# HOUSTON PLANNING COMMISSION

## AGENDA

MARCH 15, 2018

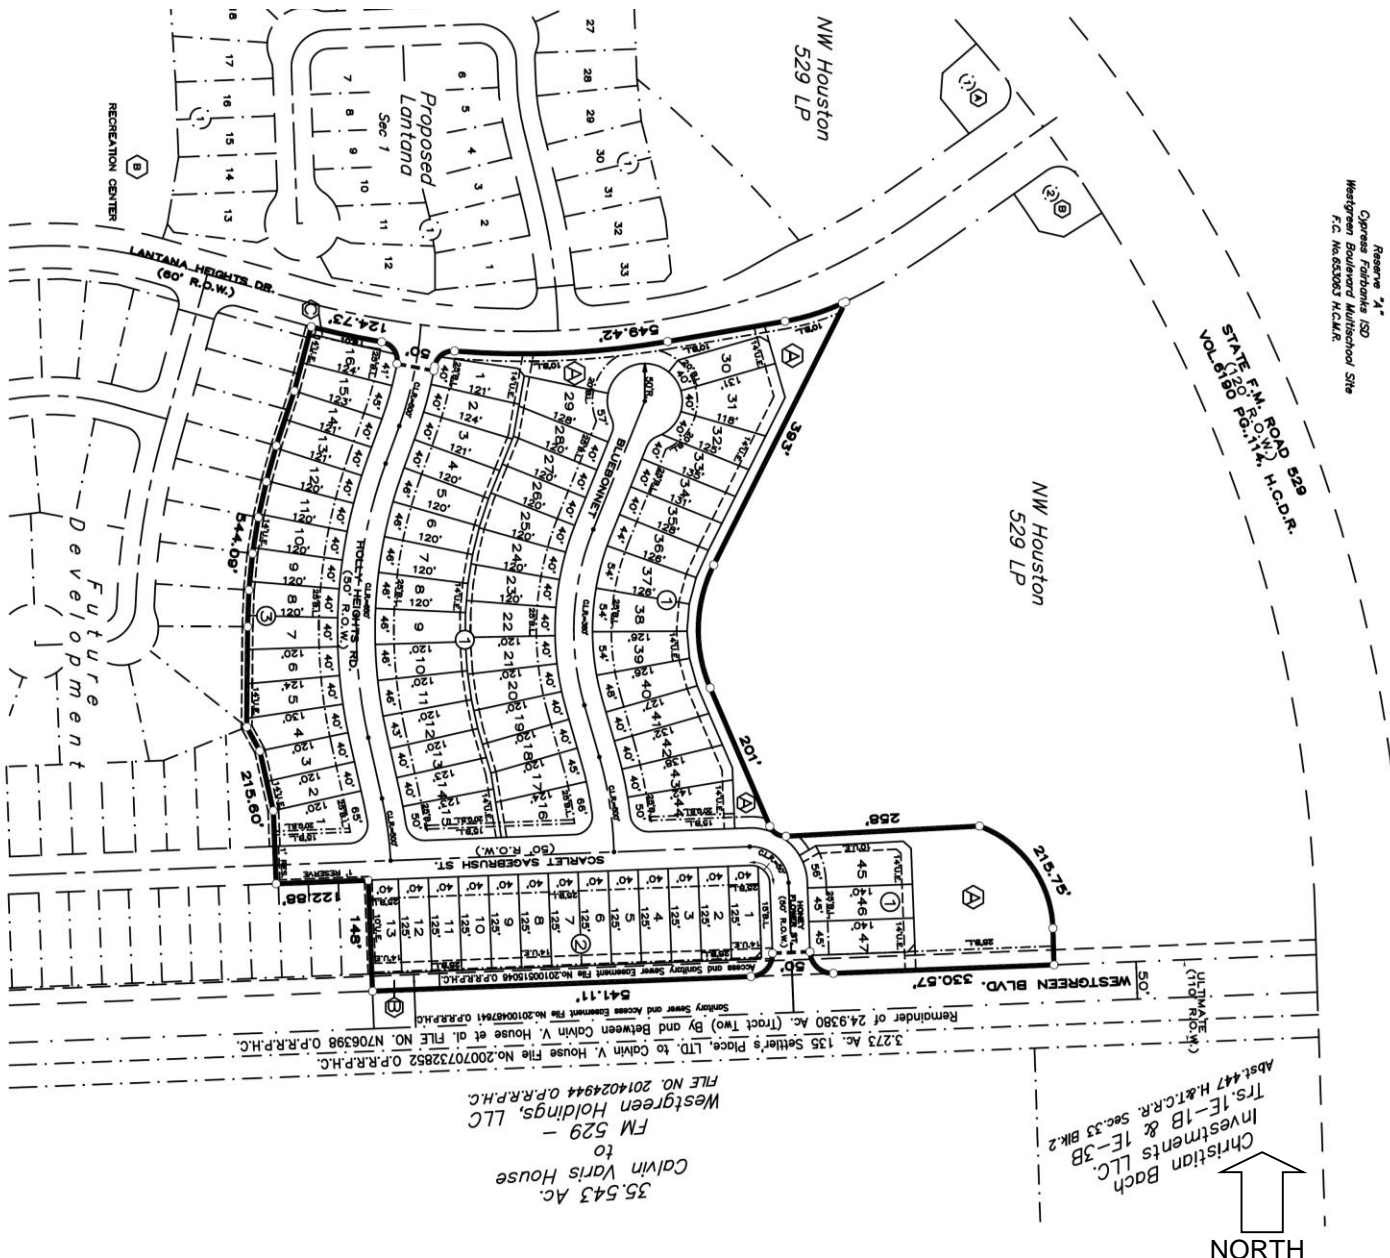
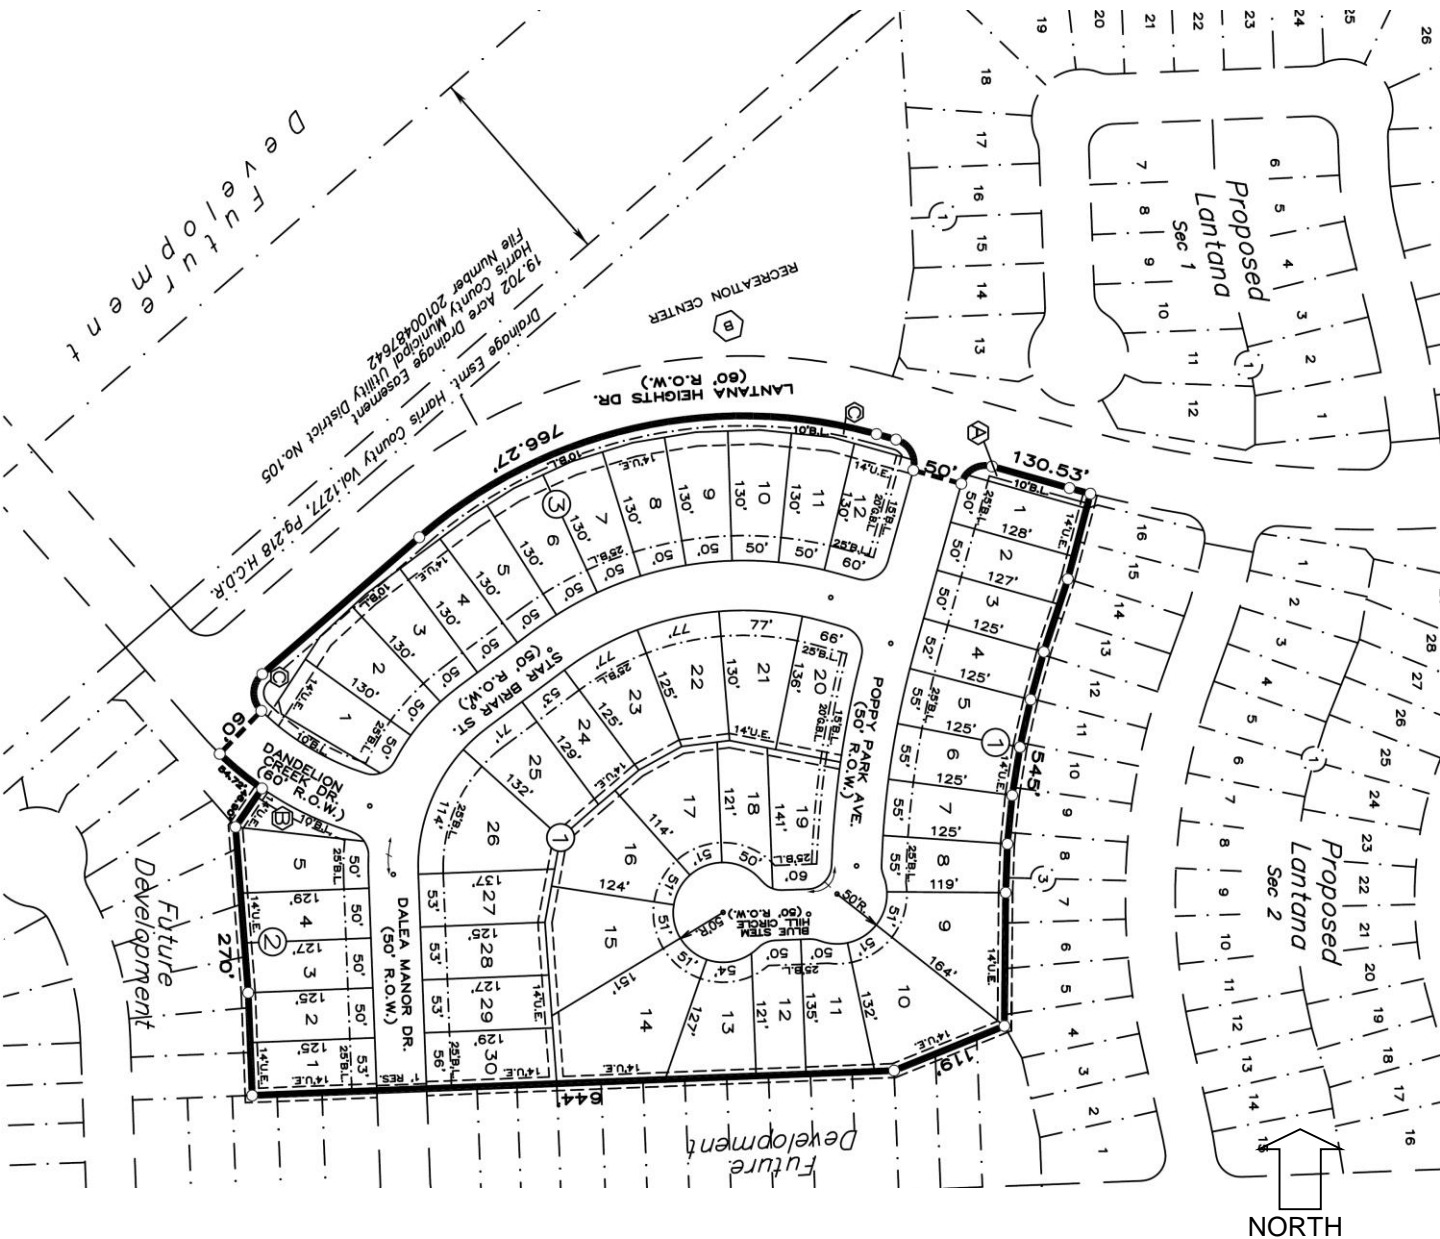
60' ROW should be provided for 41' pavement on Honey Flower Street to have separate right and left lane at the approach.

Lot 47, Block 1 should be removed as driveway will be too close to intersection with major thoroughfare and only entrance to the subdivision from Westgreen Blvd.

Plat is requested to be deferred until meeting is held with planners/developers on both sides of Westgreen to determine dedication and construction responsibilities

UVE should be checked at Dandelion Creek Dr and Lantana Heights Dr, and at Poppy Park Ave and Lantana Heights Dr.
